### Modified compressor housing and charge pressure hose

**Vehicle Manufacturer:** AUDI, VW, SEAT

**BTS reference:** T912181      **BTS-Service-Set-Nr:** T981214, T981215, T981216

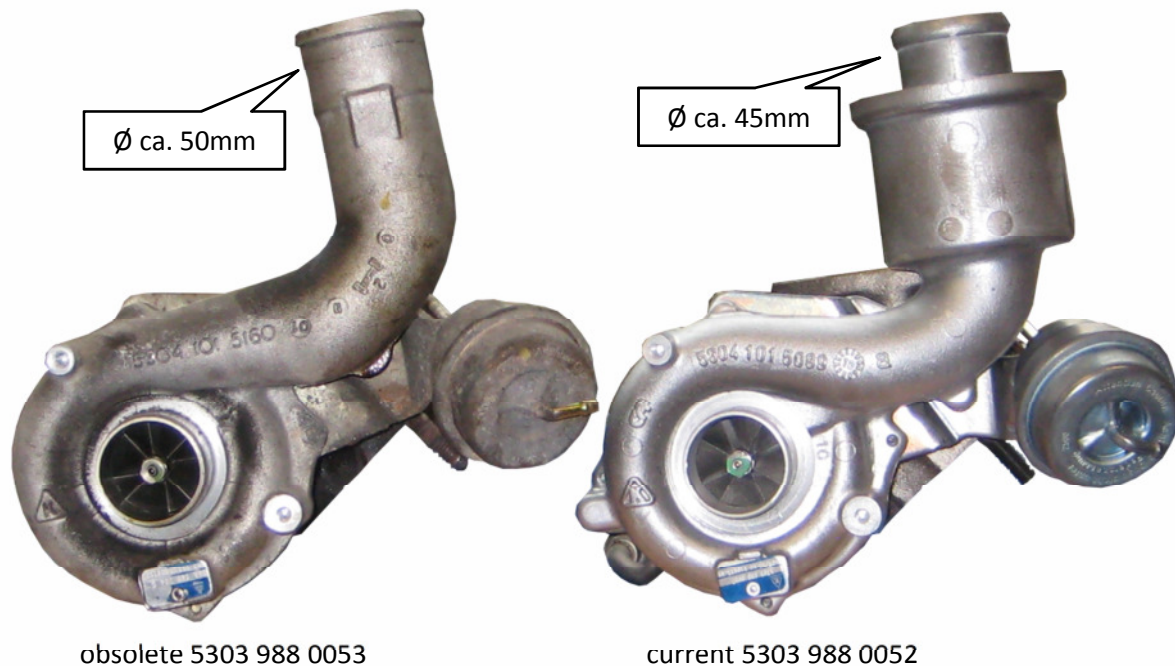
The vehicle manufacturer has made a technical change to the compressor housing, which necessitates the use of a modified charge pressure hose. Here, the cross-section dimension of the hose has changed.

If a turbocharger 5303 988 0053 without an integrated silencer has previously been installed, the following components are to be procured at OE for the installation of the new turbocharger.

When installing the turbocharger, ensure that the prop is correctly installed between the turbocharger and the engine block. Otherwise, the flange connection to the exhaust manifold can be released.
